TITLE:
CSB – SM3 Change List

SM3 Change List

This document outlines the major mechanical changes that have been made to the SM3 since release.

Fig. 1

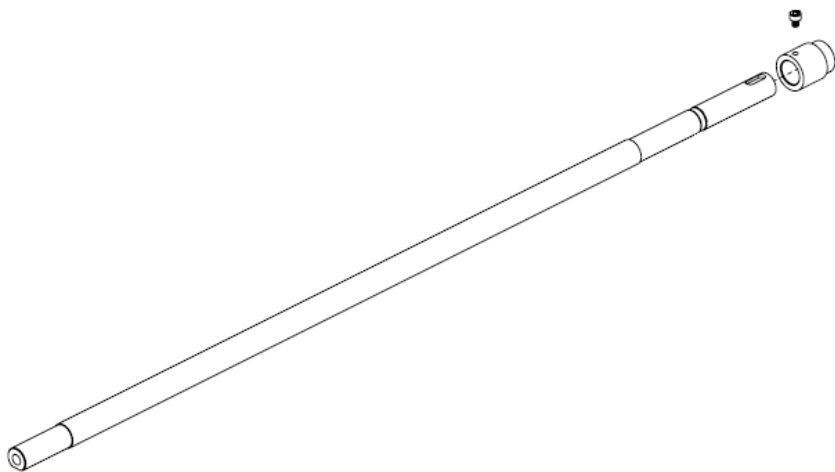
- Central drive shaft change – Starting with 140001DAY14330001
 - Redesign (723-0274-KT) replaced the original central drive shaft with a collar and keyway design to increase strength in piece. (Fig. 1)

Fig. 2

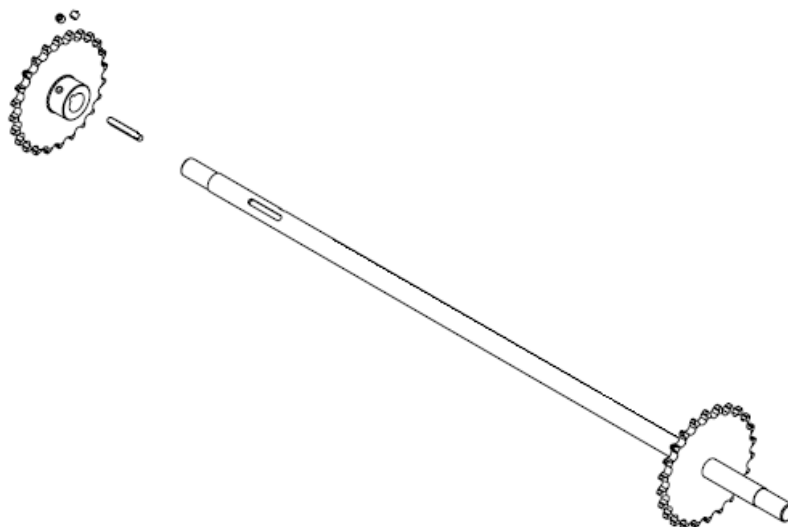
- Lower sprocket assembly change – Starting with 140001DAY14330001
 - Redesign (723-0278-KT) lower sprocket assembly with a keyway design to increase strength in piece (Fig. 2)

Fig. 3

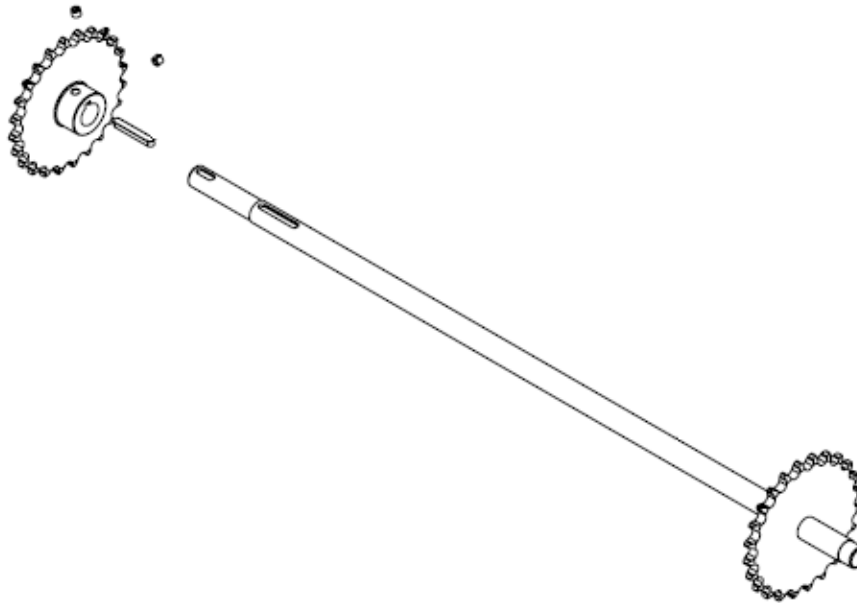
- Upper sprocket assembly change – Starting with 140001DAY14330001
 - Redesign (723-0279-KT) upper sprocket assembly with a keyway design to increase strength in piece (Fig. 3)

Fig. 4

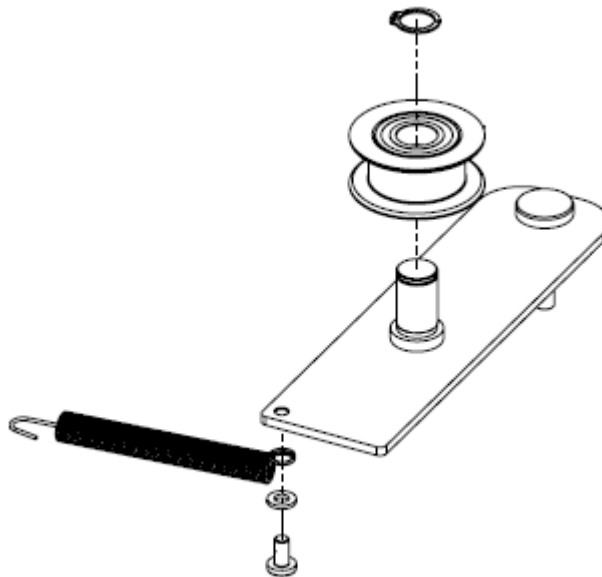
- Frame and idler assembly change – Starting with 140001DAY14490001
 - Redesign frame to accommodate new idler (723-0281) design to reduce chance of belt slippage and increase consistency in step rate (Fig. 4) **Please note that this is not a retrograde fitting that can be applied to SM3s prior to serial number 140001DAY14490001.**
